CORRIGENDA TO GTR No. 11

Global technical regulation concerning the test procedure for compression-ignition (C.I.) engines  
to be installed in agricultural and forestry tractors and in non-road mobile machinery with regard  
to the emissions of pollutants by the engine

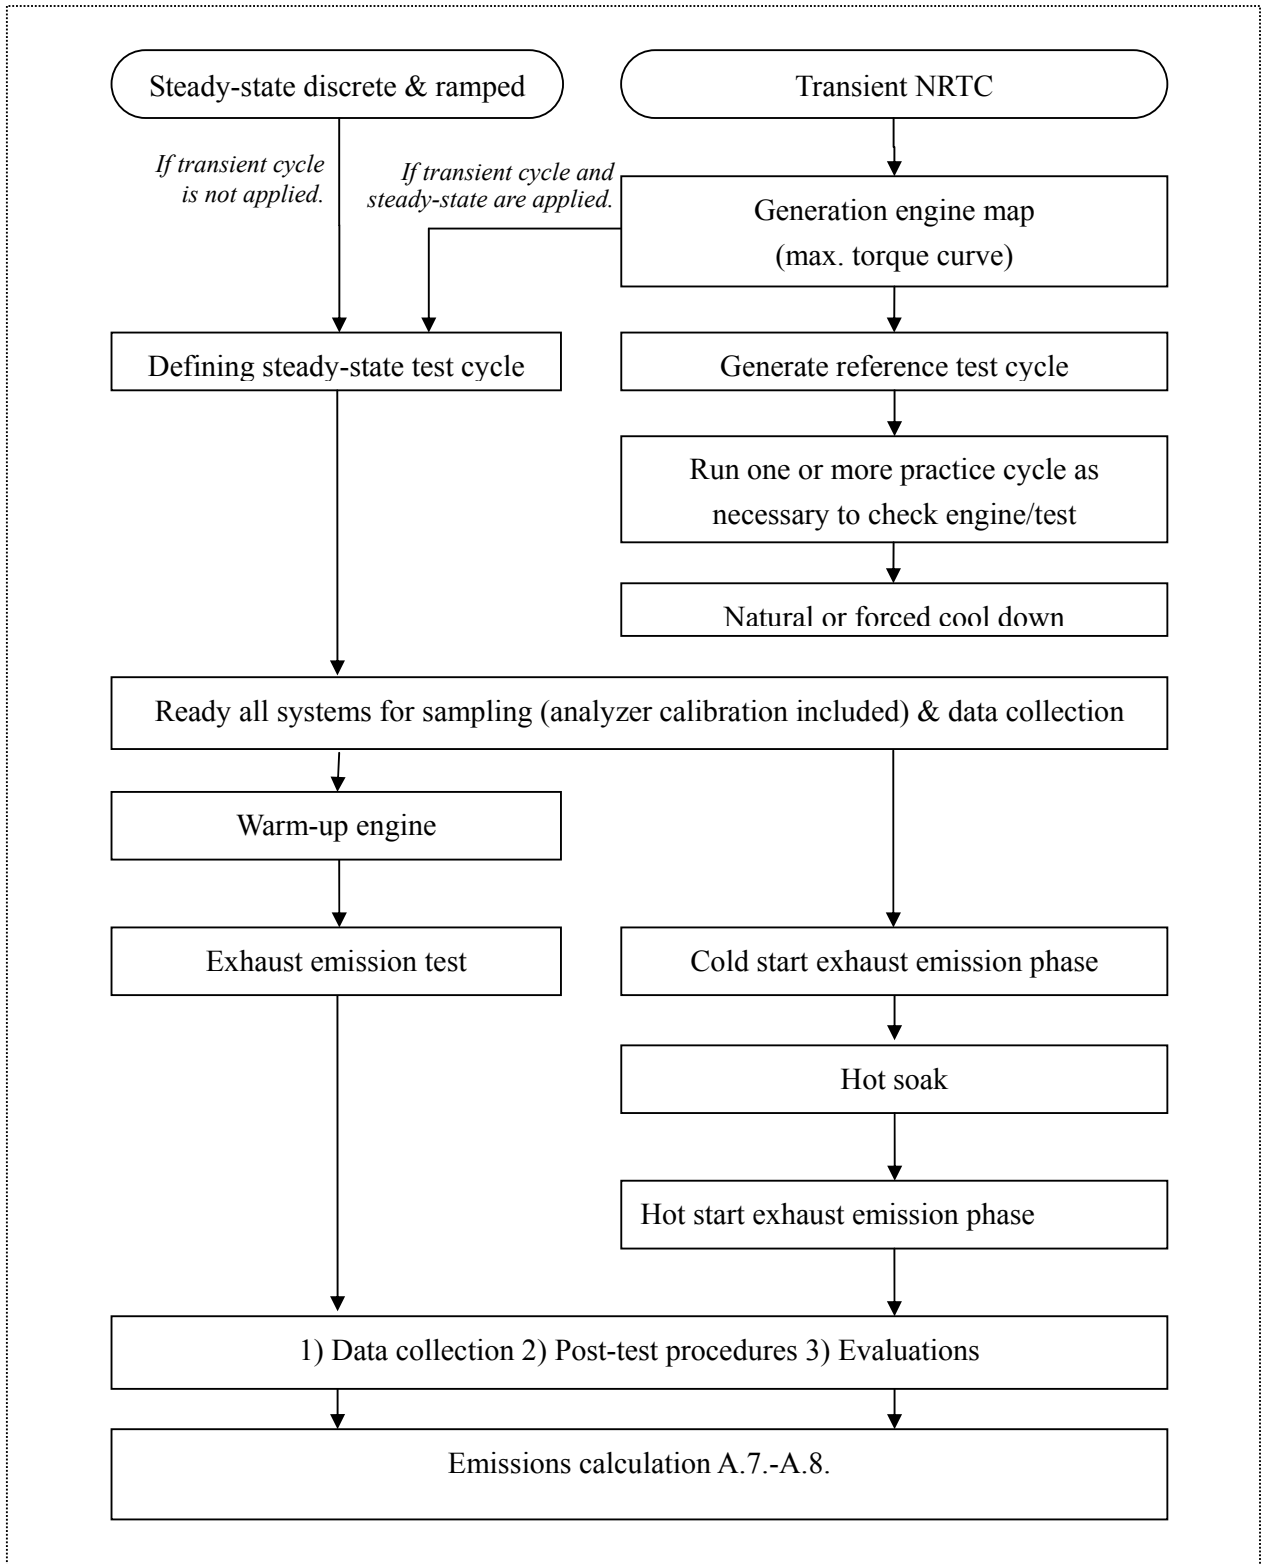
shall be conducted.
12	6.6.1. and 6.6.2.	[The downward multiplicative adjustment factor is missing and the text improved]	[See the improved text at the end of this document]
13	Figure 7.1.	Figure 7.1 – Requested operations to calculate the engine emissions in steady-state and transient test cycles (see Annexes A.7. and A.8.) [The title of figure 7.1. is inaccurate.]	Figure 7.1 – <del>Test procedures for emission measurement Requested operations to calculate the engine emissions in steady state and transient test cycles (see Annexes A.7. and A.8.)</del>
14	7.3.1.3.	(k) Any electronic integrating devices shall be zeroed or re-zeroed, before the start of any test interval. [wrong index]	(j) Any electronic integrating devices shall be zeroed or re-zeroed, before the start of any test interval.
15	7.4.2.	(see paragraph 7.7.) [Reference to wrong paragraph]	(see paragraph <del>7.7.2.</del> ) [Paragraph 7.7.2. is the paragraph related to “Generation of transient test cycle (NRTC denormalization)”]

Regarding point 12: Chapters 6.6.1 and 6.6.2. The formulation of the calculation has been simplified, the result is identical and the text has been improved for clarity.

Upward adjustment factors are **multiplied with or** added to measured emission rates for all tests in which the regeneration does not occur. Downward adjustment factors are **multiplied with or** added to measured emission rates for all tests in which the regeneration occurs. The occurrence of the regeneration shall be identified in a manner that is readily apparent during all testing.

Where no regeneration is identified, the upward adjustment factor shall be applied.

Regarding Point 17: Replacement of Figure 7.3

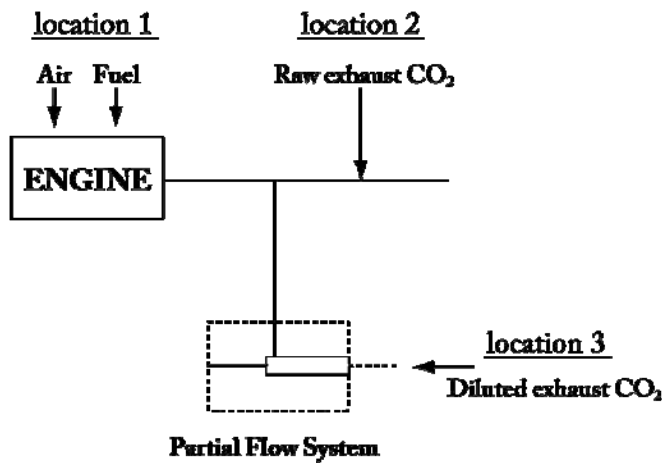
16	7.5.(h)	samples shall be evaluated according to pre- (7.3.1.4.) and post-test (7.3.2.2.) procedures. [First reference to wrong paragraph]	samples shall be evaluated according to pre- (7.3.1.5.) and post-test (7.3.2.2.) procedures. [7.3.1.5. for “PM filter preconditioning and tare weighing.”]
17	7.5. Figure 7.3	[Figure 7.3 is inaccurate.]	[The corrected figure 7.3, as prepared by Mr. Shikata, is at the end of this document.]
18	7.6. third paragraph	Where $n_{hi}$ is the high speed, defined as the highest engine speed where 70 per cent of the rated power is delivered. [Use of two kinds of power definitions in the same paragraph, maximum power and rated power. Rated power is used only in this sentence of this gr. The consistent term ‘maximum’ is used.]	Where $n_{hi}$ is the high speed, defined as the highest engine speed where 70 per cent of the <b>maximum</b> power is delivered.
19	7.7.1.1. Guidance	[adding explanation regarding the denormalization	.....In case of the steady state cycle the calculated
